**GRID CODE
CONSULTATION DOCUMENT
and REPORT TO THE AUTHORITY
Power Park Modules and
Synchronous Generating Units**

Consultation Ref	G/06
Issue	1.0
Date of Issue	14 th December 2006
Responses required by	18th January 2007
Prepared by	National Grid

2. This review is concerned with changes to the Grid Code developed through the Power Park Modules and Synchronous Generating Units Working Group. The changes proposed will:

User's System Layout

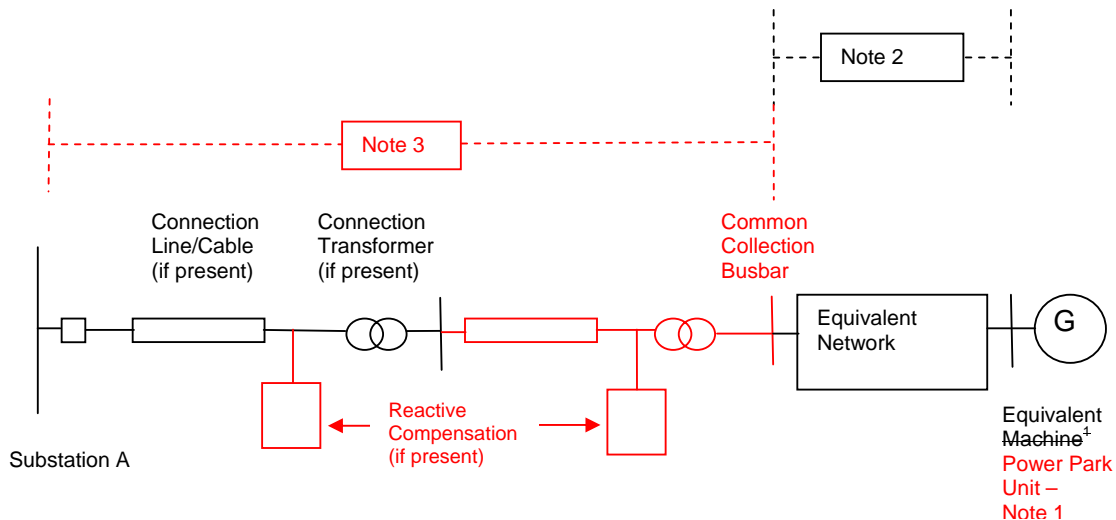
- 3) All **Plant** and **Apparatus** including the circuit breakers, transformers, lines, cables and reactive compensation plant between the **Common Collection Busbar** and Substation A shall be shown.

Figure CC.A.7.2.2b

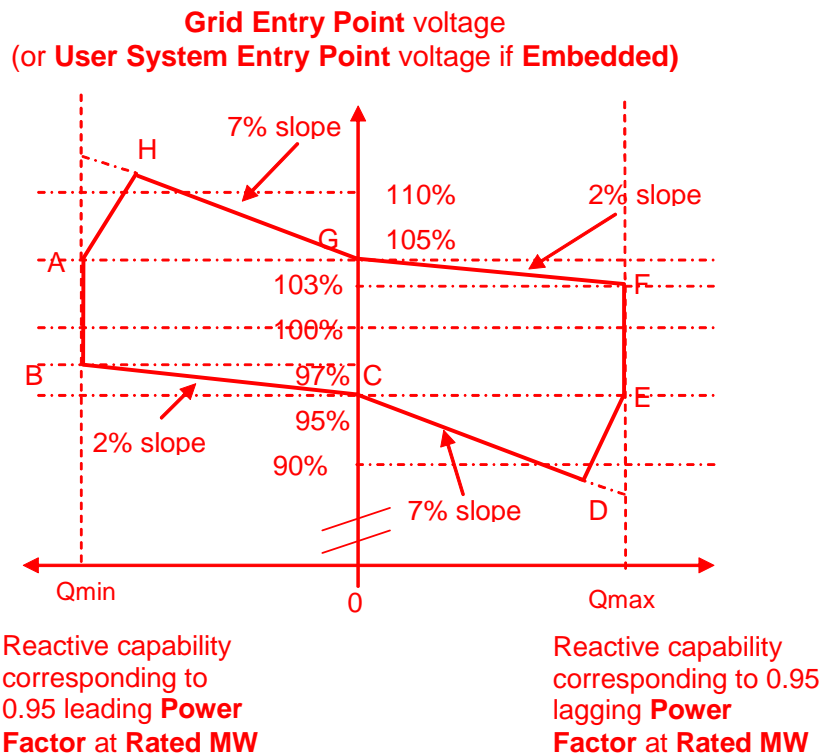
CC.A.7.2.2.4 Figure CC.A.7.2.2b shows the required envelope of operation. The enclosed area within points ABCDEFGH is the required capability range of the **Non-Synchronous Generating Unit, DC Converter or Power Park Module** within which the **Slope** and **Setpoint Voltage** can be changed.

CC.A.7.2.2.6 Should the **Reactive Power** output of the **Non-Synchronous Generating Unit, DC Converter or Power Park Module** reach its maximum lagging limit at a **Grid Entry Point voltage (or User System Entry Point voltage if Embedded)** above 95%, the **Non-Synchronous Generating Unit, DC Converter or Power Park Module** shall maintain maximum lagging **Reactive Power** output for voltage reductions down to 95%. This requirement is indicated by the line EF in figure CC.A.7.2.2b. Should the **Reactive Power** output of the **Non-Synchronous Generating Unit, DC Converter or Power Park Module** reach its maximum leading limit at a **Grid Entry Point voltage (or User System Entry Point voltage if Embedded)** below 105%, the **Non-Synchronous Generating Unit, DC Converter or Power Park Module** shall maintain maximum leading **Reactive Power** output for voltage increases up to 105%. This requirement is indicated by the line AB in figure CC.A.7.2.2b.

Figure CC.A.3.2 - Interpretation of Primary and Secondary Response Values

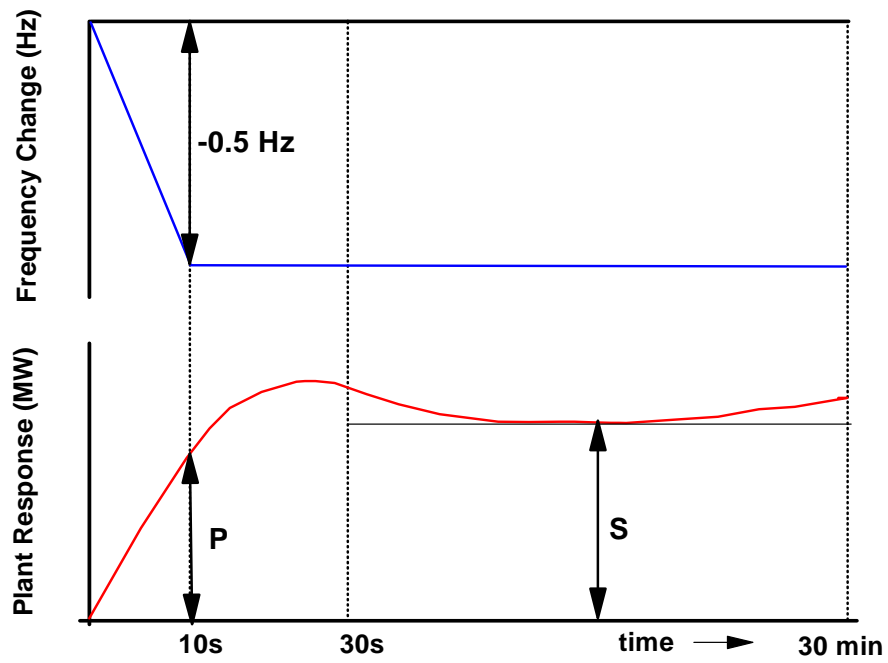
The **Primary Response** capability (P) of a **Generating Unit** or a **CCGT Module** or **Power Park Module** or **DC Converter** is the minimum increase in **Active Power** output between 10 and 30 seconds after the start of the ramp injection as illustrated diagrammatically in Figure CC.A.3.2. This increase in Active Power output should be released increasingly with time over the period 0 to 10 seconds from the time of the start of the Frequency fall as illustrated by the response in Figure CC.A.3.2.

The **Secondary Response** capability (S) of a **Generating Unit** or a **CCGT Module** or **Power Park Module** or **DC Converter** is the minimum increase in **Active Power** output between 30 seconds and 30 minutes after the start of the ramp injection as illustrated diagrammatically in Figure CC.A.3.2.

Figure CC.A.3.3 - Interpretation of High Frequency Response Values

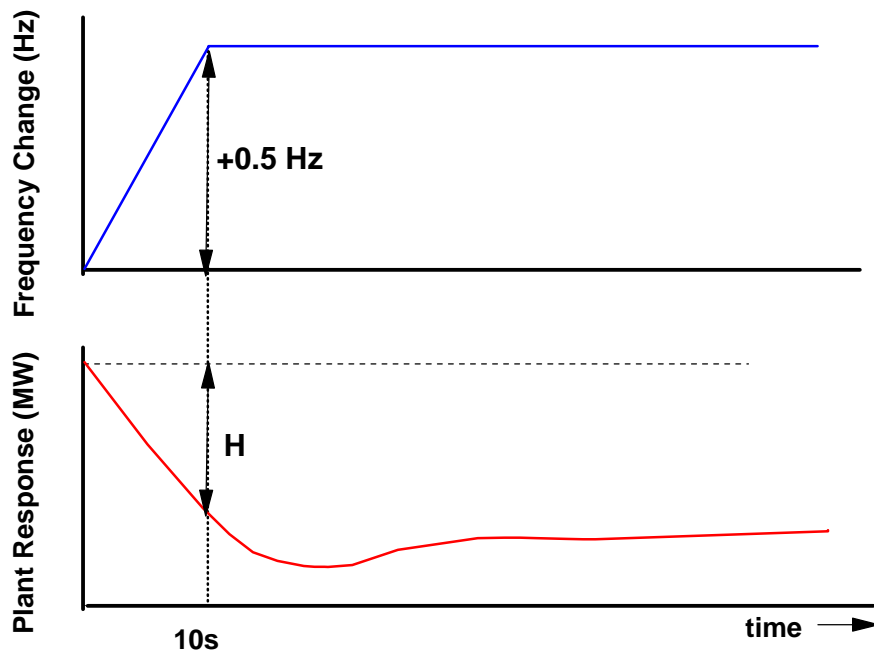
The **High Frequency Response** capability (H) of a **Generating Unit** or a **CCGT Module** or **Power Park Module** or **DC Converter** is the decrease in **Active Power** output provided 10 seconds after the start of the ramp injection and sustained thereafter as illustrated diagrammatically in Figure CC.A.3.3. This reduction in Active Power output should be released increasingly with time over the period 0 to 10 seconds from the time of the start of the Frequency rise as illustrated by the response in Figure CC.A.3.2.
